SERVICE BULLETIN # 1117

SUBJECT **NEW FUEL TANK ASSEMBLY, P/N 57475**

MODEL **1-60, 1-61** DATE **1/6/61**

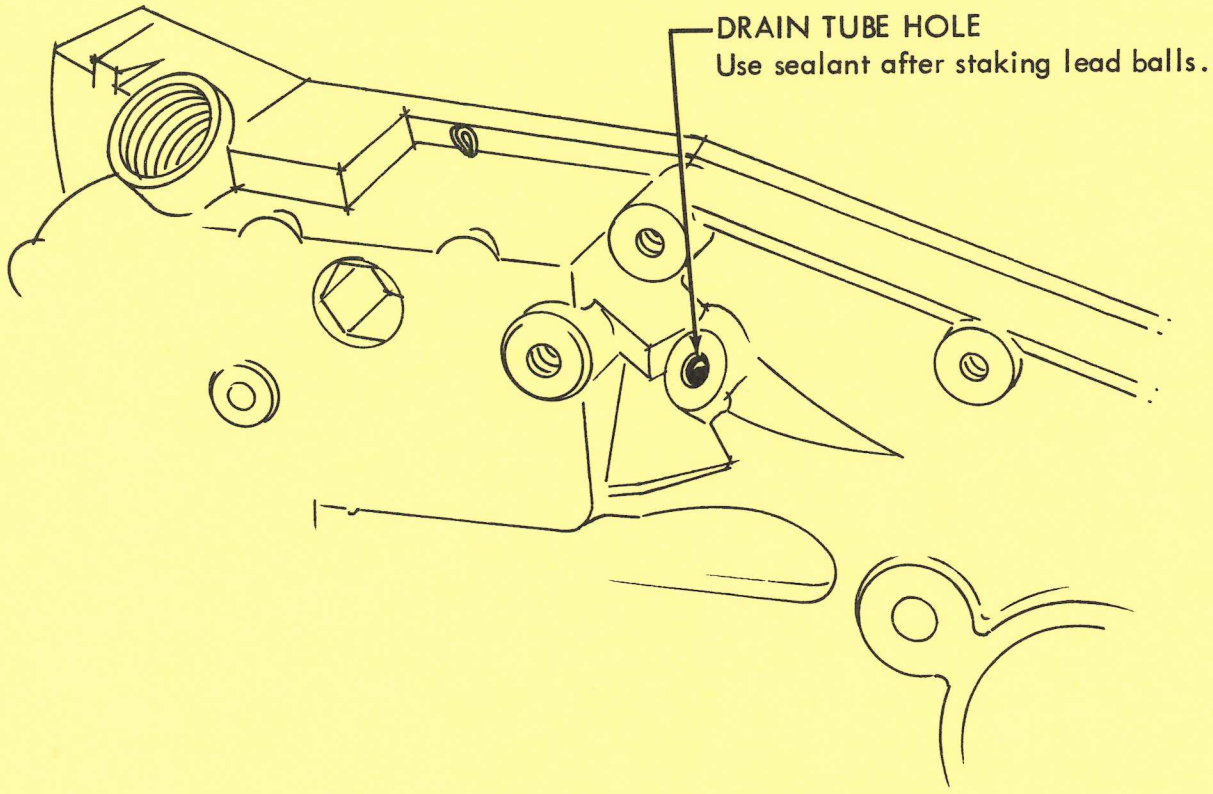
If the fuel vent system on the earlier engines contained a drain tube from the fuel tank to the transmission assembly, the drain tube hole in the top of the transmission will have to be plugged. Plug the hole by staking two 1/4 inch diameter lead balls, P/N 104506, or any similar 1/4 inch lead balls into the hole as shown in the illustration below. Use a sealant on the lead balls before staking to provide a good seal.
